Office Action Summary

10/720,392

HEO, IL ROG

DETAILED ACTION

FIGURE A. Enlargement of Figure 3A of Yoo.

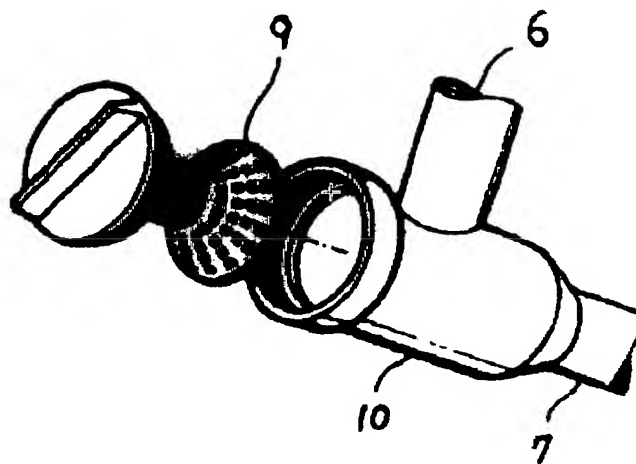
5. Claims 1-12 are rejected under 35 U.S.C. 102(b) as being anticipated by Yoo (KR Pub. No. 1994-0006388). Please refer to the enlarged Figures below in this Office Action.

Regarding claim 1, Yoo discloses a filter for a washing machine (see abstract, Figures), comprising: a cap fitted to a filter case (10) having an opening (7) via which water passes; a shaft (9) (cylindrical portion) extending from a bottom of the cap; and an extension extending from an end of the shaft (funnel shaped portion next to shaft), the extension disposed to confront the opening to filter particles included in the water, the extension having a protrusion (ring like portion next to extension) protruding from one side opposite to the cap.

Regarding claim 6, Yoo discloses a filter assembly for a washing machine, comprising: a filter case comprising: inlet (6) and outlet (7) on a circumference; and an opening (conical portion before outlet) inside to make the inlet and outlet communicate with each other; and a filter loaded in the filter case, the filter comprising (see Figures): a cap fitted to the filter case; a shaft extending from a bottom of the cap (cylindrical portion); and an extension extending from an end of the shaft (funnel like portion next to shaft), the extension disposed to confront the opening to filter particles in water, the extension having a protrusion (ring like portion next to extension) protruding from one side opposite to the cap.

Regarding claim 14, Yoo discloses a washing machine comprising: a cabinet (1); a drum (27); and a filter assembly provided in the cabinet, the filter assembly comprising: a filter case comprising: inlet (6) and outlet (7) on a circumference; and an opening (conical portion before outlet) inside to make the inlet and outlet communicate with each other; and a filter loaded in the filter case, the filter comprising (see Figures): a cap fitted to the filter case; a shaft extending from a bottom of the cap (cylindrical portion); and an extension extending from an end of the shaft (funnel like portion next to

shaft), the extension disposed to confront the opening to filter particles in water, the extension having a protrusion (ring like portion next to extension) protruding from one side opposite to the cap. Yoo differs from claim 14 in that it fails to teach a washing machine comprising: a cabinet; a tub provided in a cabinet; a drum rotatably installed in the tub and a filter assembly provided in the cabinet to filter water discharged from the outer tub.

FIGURE B. Enlargement of Figure 3B of Yoo.

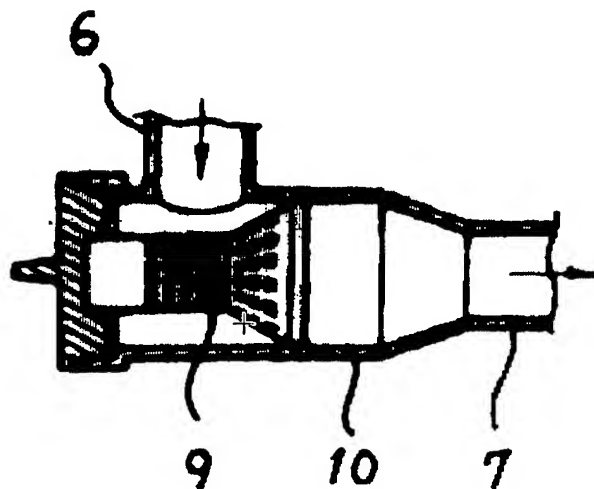
9. Claims 14-20 are rejected under 35 U.S.C. 103(a) as being unpatentable over Yoo (KR Pub. No. 1994-0006388) in view of Lee (US 6,167,733). Please refer to the enlarged Figures A and B above in this Office Action.

Figure C. Enlargement of Fig. 1 of Beier et al.

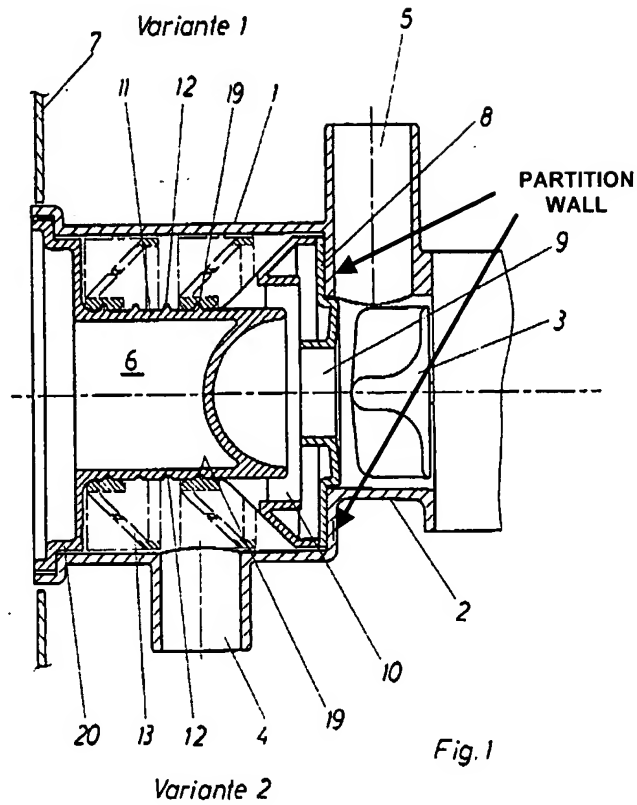
Regarding claim 13, Beier et al discloses the filter assembly of claim 6, wherein the filter case comprises: a tube having the inlet and outlet on the circumference (see Figures); a partition wall (see Figure C) provided in the tube to partition an internal space of the tube into first and second chambers communicating with the inlet and outlet, respectively; and the opening perforating the partition wall (see Figure C).

Regarding claim 21, Beier et al discloses the filter assembly, wherein the filter case comprises: a tube having the inlet and outlet on the circumference (see Figures); a partition wall (see Figure C) provided in the tube to partition an internal space of the tube into first and second chambers communicating with the inlet and outlet, respectively; and the opening perforating the partition wall (see Figure C).

Figure D. Enlargement of Fig. 2 of Beier et al.

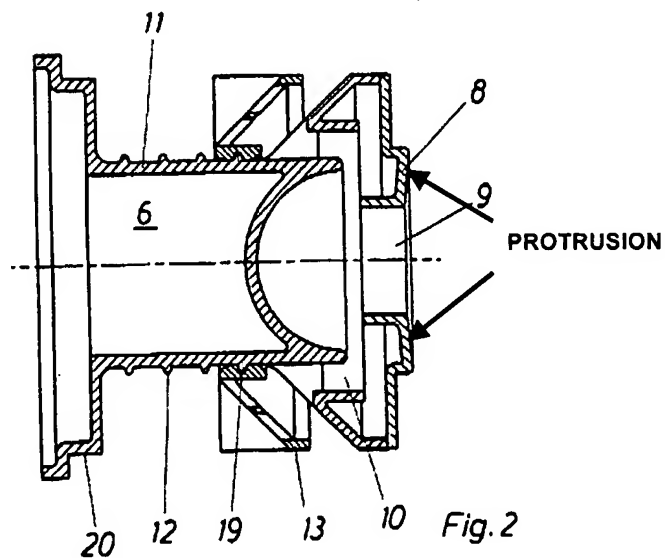
Regarding claim 6, Beier et al discloses a filter assembly for a washing machine, comprising: a filter case (1) comprising: inlet (4) and outlet (5) on a circumference; and an opening (9) inside to make the inlet and outlet communicate with each other; and a filter loaded in the filter case, the filter comprising (see Figures): a cap (20) fitted to the filter case; a shaft (11) extending from a bottom of the cap (see Figures); and an extension (8) extending from an end of the shaft, the extension disposed to confront the opening to filter particles in water, the extension having a protrusion (see Figure D) protruding from one side opposite to the cap.
